**DAM SAFETY INSPECTION  
REPORT**

**DAN RIVER STEAM STATION  
ROCKINGHAM COUNTY,  
NORTH CAROLINA**

**PROJECT NO. 09-4157  
JULY 2009**

**DAM SAFETY INSPECTION REPORT  
DAN RIVER STEAM STATION  
ROCKINGHAM COUNTY, NORTH CAROLINA  
PROJECT NO. 09-4157**

PRIMARY BASIN DIKE  
(NEXT TO PLANT ACCESS ROAD)

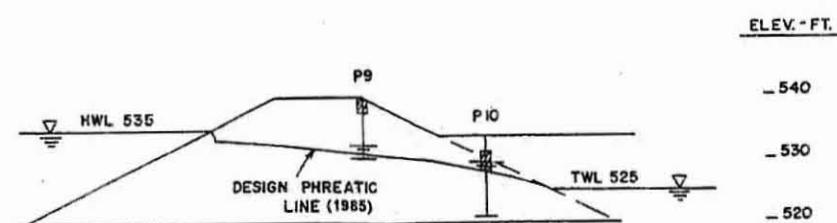
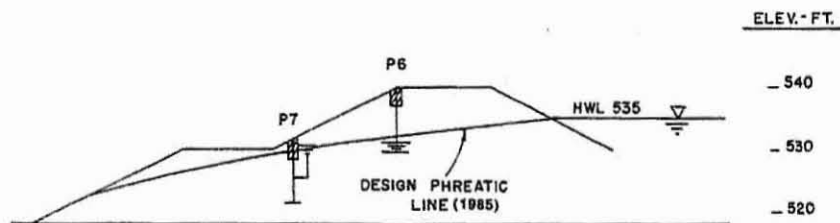
NOTE: 2006 INSPECTION SHOULD ADD A  
SECTION CONTAINING OW2 AND OW3.
